PUBLIC ARTS ADVISORY BOARD STAFF REPORT

1880 Dr. Andre's Way

Meeting	File No.	Application Type
February 25, 2025	2025-015 (Bldg. 1880 Façade 1) 2025-016 (Bldg. 1880 Façade 3) 2025-017 (Bldg. 1880 Façade 6) 2025-018 (Bldg. 1880 Façade 7) 2025-019 (Bldg. 1880 Façade 8)	2025-020 (Bldg. 1880 Façade 9) 2025-021 (Bldg. 1880 Façade 10A) 2025-022 (Bldg. 1880 Façade 10 B) 2025-023 (Bldg. 1880 Façade 11)
Property Owner	Applicant /Agent	
JMS Boynton Beach	Steven Michael

Consideration of the installation of 9 murals on Building 1880 located at 1880 Dr. Andre's Way.

Building 1880 Façade 1 (File No. 2025-015)

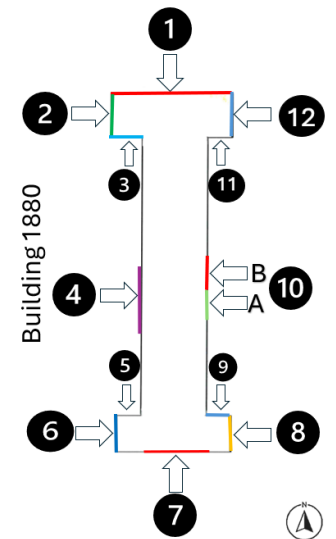
The mural features a mix of abstract patterns, geometric motifs, and a tie-dye spiral, using a bold color palette of blue, pink, purple, red, and yellow. The design is fragmented by black diagonal lines, creating a patchwork effect that visually separates the various elements. While the intent may be to introduce vibrancy, the lack of thematic cohesion results in a disjointed composition that does not contribute to a unified artistic statement.

While the mural complies with Appendix A of the LDRs, meeting the definition of public art, its execution and placement raise concerns. The upper-band location isolates the artwork from pedestrian interaction, limiting its effectiveness in enhancing the site's public-facing aesthetic. Additionally, the varying artistic styles within the mural create a fragmented appearance, lacking a clear focal point or narrative cohesion.

While the mural complies with LDR Section 8.5.3(C) regarding coverage, placement, and absence of commercial messaging, its visual impact and thematic execution remain questionable. The composition appears more decorative than conceptually driven, raising the issue of whether it effectively serves the purpose of enhancing public art within the district.

Building 1880 Façade 2 (no mural permit application submitted)

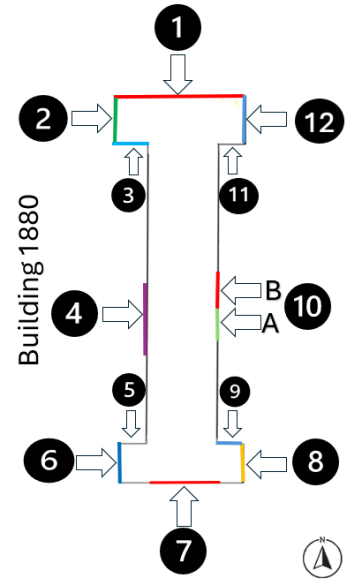
The existing mural is located on Façade 2 on the west elevation of Building 1880. No mural permit application was submitted.

Building 1880 Façade 3 (File No. 2025-016)

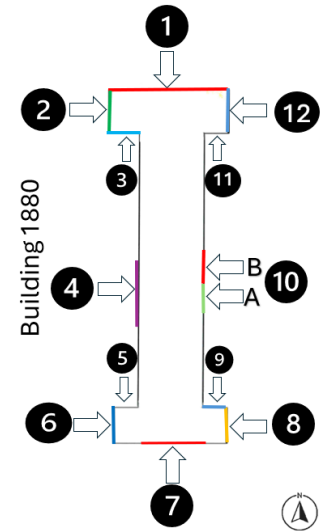
The mural on Façade 3 spans 12 feet high by 20 feet wide (240 sq. ft.), covering 100% of the west elevation of Building 1880. It features large pink floral motifs set against a solid black background, with the text “Andre Design District” prominently displayed in bold pink uppercase letters. The mural is centered around an entrance door, incorporating a minimalistic floral arrangement that extends to the adjacent wall. The use of soft gradients and outlined shading in the flowers provides a sense of depth and movement, contrasting with the stark black background.

While the mural meets the general definition of public art per Appendix A of the LDRs, its integration with commercial messaging raises concerns regarding compliance with **LDR Section 8.5.3(C)(4)**, *the mural shall be predominantly pictorial, with text limited to no more than 5 percent of the proposed mural size*, except for text used to create the graphic. The “Andre Design District” text functions as identification signage rather than an artistic component, exceeding the 5% text limit established for murals. According to LDR Section 4.6.7, text within murals that serves a commercial or branding function is classified as a wall sign, requiring a separate sign permit. In this case, the mural blurs the line between artistic expression and business advertising, making it non-compliant with the mural regulations without a sign waiver.

From a design perspective, the composition is visually simplistic, relying heavily on repetitive floral imagery without a strong narrative or thematic depth. The black background, while effective in emphasizing the pink elements, creates a stark, unfinished aesthetic, especially around architectural elements like the doorway and adjacent window. The placement of the mural does not fully utilize the façade’s spatial potential, leaving significant portions of the surface **

unadorned and contributing to a sense of incompleteness. The floral imagery, while decorative, lacks the distinctive artistic character or conceptual intent seen in more immersive public art installations.

Additionally, the condition of the mural raises concerns about long-term maintenance. The black painted façade appears to have fading and uneven wear, which may accelerate deterioration of both the background and floral elements. The proximity to an entryway also increases the likelihood of scuffing, dirt accumulation, and weathering, particularly around the door and lower portions of the mural. Without clear maintenance commitments, the artwork risks degrading quickly, impacting its overall effectiveness as a public art feature.

While the mural partially meets LDR requirements for coverage, placement, and façade integration, its commercial branding, lack of thematic depth, and maintenance concerns present significant compliance issues. The use of text exceeds allowable limits, making it functionally a sign rather than a mural, and the overall artistic execution lacks narrative cohesion or transformative impact. This raises the question of whether the mural genuinely enhances the district’s creative vision or simply serves as a stylized branding tool for the development.

Building 1880 Façade 6 (File No. 2025-017)

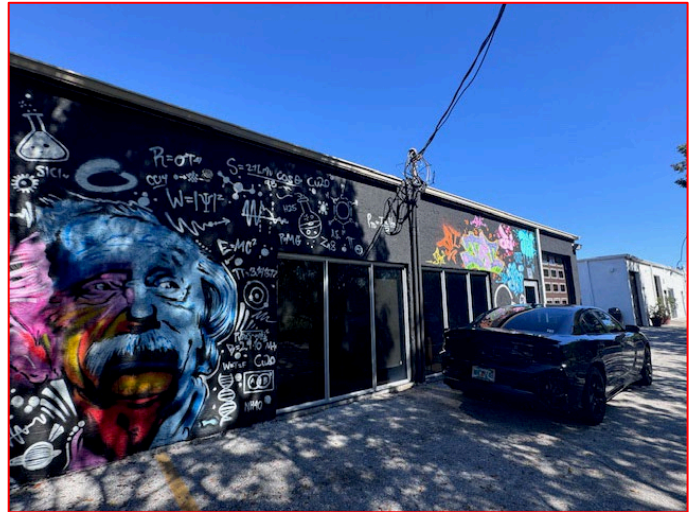
The mural on Façade 6 spans 12 feet high by 50 feet wide (600 square feet), covering 100% of the west elevation of Building 1880. It features a purple Chevrolet Impala in motion, set against a beach-inspired background with mechanical and automotive imagery. The mural includes a large transmission illustration, multiple automotive brand logos, and industrial gear motifs, creating a dynamic yet visually fragmented composition. Above the artwork, a wall-mounted sign reading "Performance Transmission" is prominently displayed.

The Performance Transmission sign is non-conforming and lacks a permit, making it a violation of the sign code under **LDR Section 4.6.7(B)**, *it shall be unlawful for any persons to post, display, change, or erect a nonexempt sign or a sign structure, that requires a permit, without first having obtained a permit therefor. Signs or sign structures erected without a valid permit shall be deemed in violation and it shall be mandatory to obtain a permit, based on this Section, or else remove the sign or sign structure.* The MROC zoning district only allows wall signs if they face a dedicated street or I-95. Since this sign does not meet either requirement, it is not permitted and must be removed. Furthermore, it does not qualify as a building sign under the code since it functions as a commercial advertisement for the automobile repair shop rather than an architectural element.

In addition to the signage violation, the mural fails to comply with the definition of a mural under Appendix A of the LDRs, which defines a mural as *"an original, one-of-a-kind unique mosaic, painting, or graphic art or combination thereof (including collage effects) that is professionally applied to aesthetically enhance the exterior of a building or accessory structure such as a dumpster enclosure, fence, or site wall, that does not contain any brand name, product name, letters of the alphabet spelling or abbreviating the name of any product, company, profession, or business, or any logo, trademark, trade name, or other commercial message."* The inclusion of automotive brand logos such as Chevrolet, Honda, Ford, Audi, and Dodge constitutes a direct violation of this definition, as murals are strictly prohibited from incorporating brand names, logos, trademarks, or commercial messaging.

According to the United States Patent and Trademark Office (USPTO), the automotive brand logos displayed on the right side of the mural are all registered trademarks. As a result, these logos must be removed from the mural as a condition of approval to ensure compliance with LDR mural regulations. Their inclusion raises concerns regarding the blurred boundary between public art and business advertising, undermining the intent of the mural ordinance.

From an artistic standpoint, the mural demonstrates technical skill, particularly in shading, reflections, and depth. However, its composition is cluttered, with competing elements—beach scenery, mechanical components, and corporate branding—lacking thematic cohesion. The coexistence of realistic and abstract styles further contributes to visual disarray, making the mural appear

more promotional than expressive. The use of bright yellow, pink, and blue hues in the background creates a chaotic visual effect, which detracts from the overall quality of the piece.

The placement of the mural also presents challenges. The non-conforming sign disrupts the visual flow of the artwork, functioning more like a billboard than an integrated artistic element. The dark blue background of the sign contrasts awkwardly with the sky, creating an unintended separation that breaks the continuity of the design. Additionally, the low positioning of the artwork near the pavement makes it susceptible to wear, fading, and potential vandalism over time. The blue cloud-like outline surrounding the sign diminishes the mural's aesthetic integrity, further weakening its effectiveness as a cohesive public art installation.

Building 1880 Façade 7 (File No. 2025-018)

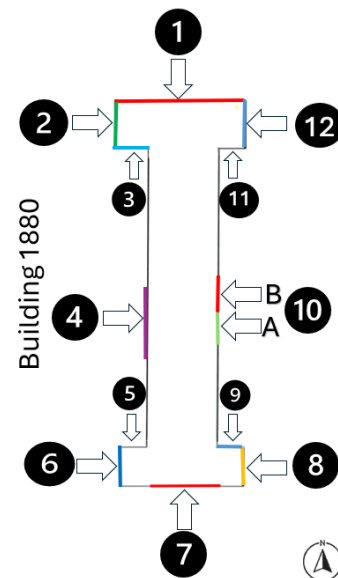
However, the right portion of the façade previously contained a graffiti-style mural featuring the letters "JRI" and various colorful graffiti tags, which were separate from the Einstein artwork. As seen in the "Before" image, the JRI mural had a distinct composition, with multiple overlapping lettering styles, bright neon colors, and a spray-paint aesthetic, making it stylistically disconnected from the Einstein mural. Since then, the "JRI" graffiti elements have been removed, but their prior existence raises questions regarding compliance and the intended artistic

Per LDR Section 8.5.3(C)(3), *each façade is limited to one mural*, although a consistent image or theme may continue across a contiguous wall. Given the clear stylistic and thematic disconnect between Einstein's portrait and the now-removed graffiti lettering, there is a strong argument that this façade previously contained two separate murals rather than a single, unified artistic statement.

If the graffiti lettering was originally considered a separate artistic installation, it should have required a separate mural permit to comply with the regulations.

While the removal of the "JRI" graffiti elements has improved thematic unity, remnants of the prior mural may still be present, requiring clarification on whether the applicant intends to repaint or restore the affected area. The Public Art Advisory Board must evaluate whether the modifications made to Façade 7 sufficiently align with the original permit request or if additional approvals are necessary.

From an artistic standpoint, the Einstein mural demonstrates a high level of technical skill, particularly in its use of color gradients, lighting effects, and expressive detailing. The mathematical notations and scientific symbols add a layer of intellectual depth, reinforcing Einstein's legacy as a physicist. However, the black background and exposed location raise concerns about long-term maintenance, as dark paint is prone to fading and accumulating dirt. The vibrant colors in Einstein's face may also be susceptible to sun exposure, requiring periodic restoration. A clear maintenance plan must be in place to ensure the mural retains its visual quality over time.

Overall, while the Einstein portion of the mural meets the artistic and thematic criteria of public art, the previous presence of the "JRI" graffiti mural raises compliance concerns. The Board must determine whether the removal of the graffiti elements sufficiently resolves the issue or if further action is needed to ensure full regulatory alignment with mural permit requirements.

Building 1880 Façade 8 (File No. 2025-019)

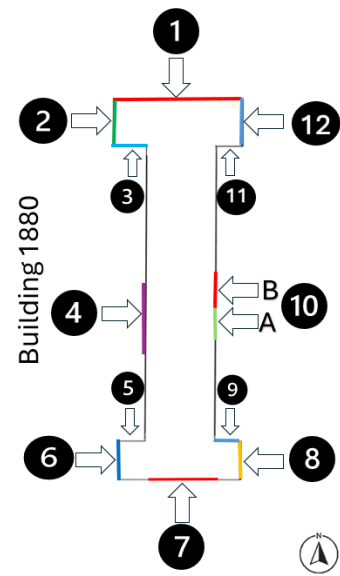
The mural on Façade 8 spans 12 feet high by 30 feet wide (360 square feet), covering 100% of the east elevation of Building 1880. The mural features portraits of four prominent historical figures, each depicted in a distinct background color—blue, pink, green, and yellow—creating a visually striking composition. The subjects appear to be individuals of great cultural and historical significance, symbolizing leadership, activism, and justice.

From an artistic standpoint, the mural demonstrates strong composition and technical skill, particularly in its use of bold color blocking and expressive brushwork to capture the likeness of each figure. The choice of vivid, contrasting colors enhances the mural's visual

impact and thematic clarity, ensuring that each figure stands out while maintaining a sense of cohesion within the overall piece. The stylized rendering of facial features and clothing details contributes to the mural's recognizability and cultural depth.

However, while the mural meets artistic and regulatory standards, maintenance concerns arise due to its exposed location and bold color palette. The intensity of the colors may be susceptible to fading, particularly under direct sunlight, which could diminish the mural's vibrancy over time. Additionally, the paint application appears to extend around building elements such as pipes and window edges, which may result in wear and inconsistencies if the mural is not properly sealed or maintained.

Building 1880 Façade 9 (File No. 2025-020)

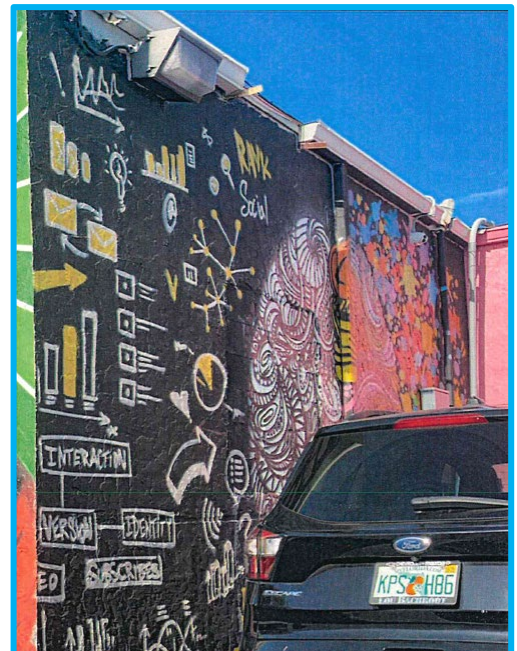
While the mural presents an intriguing visual approach, its composition appears fragmented, lacking a clear focal point or cohesive artistic narrative. The scattered arrangement of symbols and text results in a disorganized aesthetic, making it challenging to interpret as a unified artistic expression. The inclusion of words such as "Interaction," "Identity," "Subscribers," and "Rank Social"

raises concerns regarding potential thematic ambiguity, as the mural blurs the line between conceptual art and informational design.

Per LDR Section 8.5.3(C)(3), each façade is limited to one mural, and while this piece appears to be a single composition, the varied design elements and scattered text create an unstructured visual hierarchy, potentially diminishing its effectiveness as a public art installation. Additionally, the text components must comply with LDR Section 8.5.3(C)(4), which limits text in murals to no more than 5% of the overall mural size, unless incorporated as part of a graphic design. The prominent use of words and labels throughout the mural may exceed this limit.

From a technical perspective, the use of a black background raises durability concerns, as dark colors are prone to fading, accumulating dirt, and showing signs of wear more quickly than lighter hues. The presence of detailed line work and small-scale text elements further increases the risk of deterioration, particularly in high-exposure areas. Without a structured maintenance plan, portions of the mural may fade unevenly, compromising its readability and artistic impact.

Overall, while the mural aligns with the definition of public art under Appendix A of the LDRs, its lack of a cohesive composition, potential text compliance issues, and long-term durability concerns warrant further evaluation by the Public Art Advisory Board. The Board should assess whether modifications are necessary to enhance the mural's thematic clarity, ensure text compliance, and establish a maintenance strategy that preserves the integrity of the artwork over time.

Building 1880 Façade 10A (File No. 2025-021)

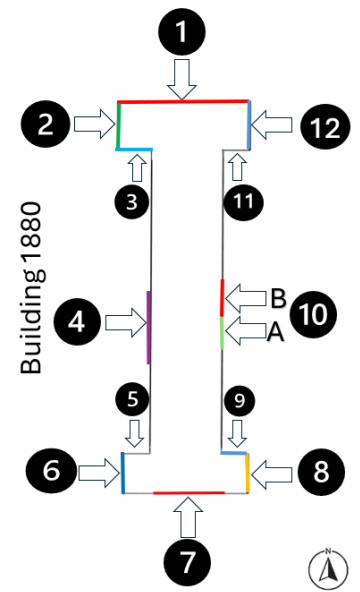
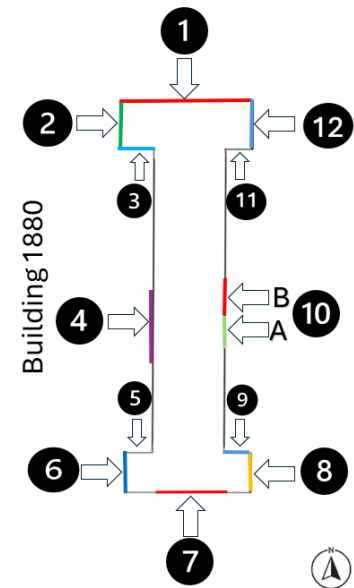
The mural on Façade 10A spans 12 feet high by 5 feet wide, with an additional 8 feet by 5 feet section above a window (100 square feet total), covering 100% of the east elevation of Building 1880. The "Before" image of the mural featured a prominent symbolic eye with colorful detailing, surrounded by various inspirational hashtags and phrases promoting self-love, empowerment, and positivity. The background consisted of a pastel gradient, blending pink, teal, and white tones to create a visually soft yet impactful message.

The "After" image shows significant alterations to the façade, with most of the previous mural removed or painted over in a muted blue tone. The eye motif remains faintly visible, but the text-heavy content and hashtag phrases have been eliminated. The visual impact of the façade has been greatly reduced, shifting from a message-driven artistic piece to a more subdued color transition with minimal remaining design elements.

Per LDR Section 8.5.3(C)(4), *text within a mural shall be predominantly pictorial, with written elements limited to no more than 5% of the overall mural size, except for text incorporated as a graphic element.* The "Before" version of this mural likely exceeded this limitation, as the hashtags and phrases dominated the composition, making the façade more of a message board than a pictorial mural. The removal of the text components in the "After" image aligns the artwork more closely with mural regulations, ensuring compliance with the LDR.

From a design perspective, the original mural featured a clear theme centered on personal empowerment and positivity, with text playing a dominant role in conveying the message. However, its text-heavy nature and reliance on hashtags may have contributed to a commercialized or promotional aesthetic, blurring the line between public art and branding. The simplified "After" version, while compliant, now appears incomplete and lacks the previous vibrancy and thematic clarity.

Overall, the modifications to Façade 10A have addressed prior compliance issues related to text size and mural definition. However, the altered version now lacks the thematic impact of the original, and its partial removal raises questions about the intended final state of the façade. The Board may need clarification on whether this façade is considered finalized or if further mural work is planned to ensure artistic and regulatory alignment.

Building 1880 Façade 10B (File No. 2025-022)

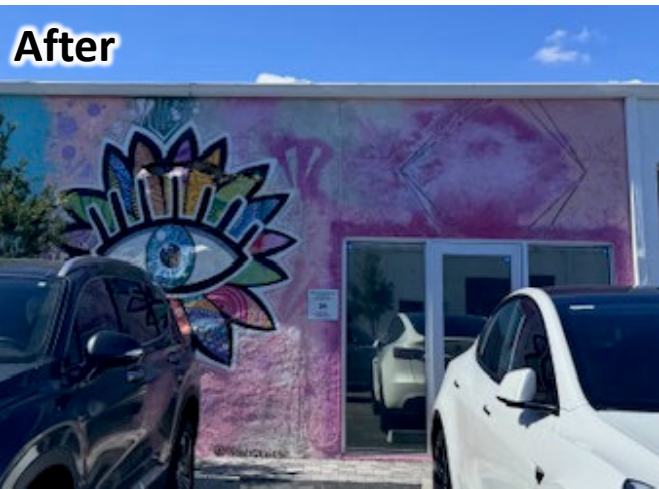
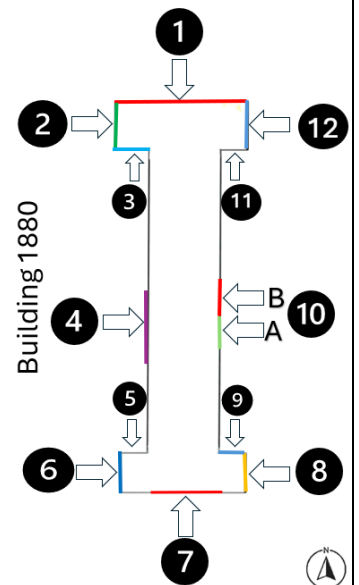
The mural on Façade 10B spans 12 feet high by 20 feet wide (240 square feet), covering 100% of the east elevation of Building 1880. The "Before" image showcases a bold, colorful eye symbol within a lotus-like design, accompanied by text elements, including "ZEK BROWS Studio" and the phrase "#youareenough". The background is a gradient of pink and teal tones, incorporating soft abstract textures and faint images of faces within the design.

The "After" image reveals a significant reduction in mural content, with the studio branding and much of the text removed. The eye design remains, but it appears more faded, and the background has been muted, leaving only faint traces of the previous artwork. The erasure of text and branding elements aligns the mural with regulatory requirements but also results in a loss of vibrancy and thematic clarity.

Per LDR Section 8.5.3(C)(4), *text within a mural shall be predominantly pictorial, with written elements limited to no more than 5% of the overall mural size, except for text incorporated as a graphic element.* The "Before" version likely exceeded this threshold, as both hashtags and business-related text were dominant features. The removal of commercial references ensures compliance with mural

regulations, as business signage must be reviewed under LDR Section 4.6.7, which governs signage regulations separately from murals.

The altered mural now appears faded and incomplete, raising aesthetic concerns regarding its maintenance and artistic integrity. The remaining elements lack the boldness and definition of the original piece, making it unclear whether this is a final iteration or if additional refinements are intended. The faint outlines of the former design suggest an incomplete removal, which may require further intervention to either restore the remaining artwork or repaint the façade entirely.

From a technical standpoint, the pastel background is highly susceptible to fading and weather-related wear, particularly given its prominent exposure. The inconsistent fading and residual ghosting of the prior design create an unfinished appearance, which could diminish the overall aesthetic quality of the building's exterior. The lack of a clear preservation plan for the altered mural may result in further deterioration, necessitating a defined maintenance strategy to prevent further decline.

Overall, while the removal of non-compliant text and branding elements ensures LDR compliance, the resulting mural appears diminished in both impact and artistic execution. The Public Art Advisory Board may need clarification on whether the current version is final or if additional restoration efforts are planned to enhance cohesion, durability, and visual appeal.

Again, the submitted maintenance plan proves to be ineffective and not implemented by the property management thus, not meeting the criteria number 3, 4, and 8 listed in LDR Section 8.5.2(A), criteria for board action.
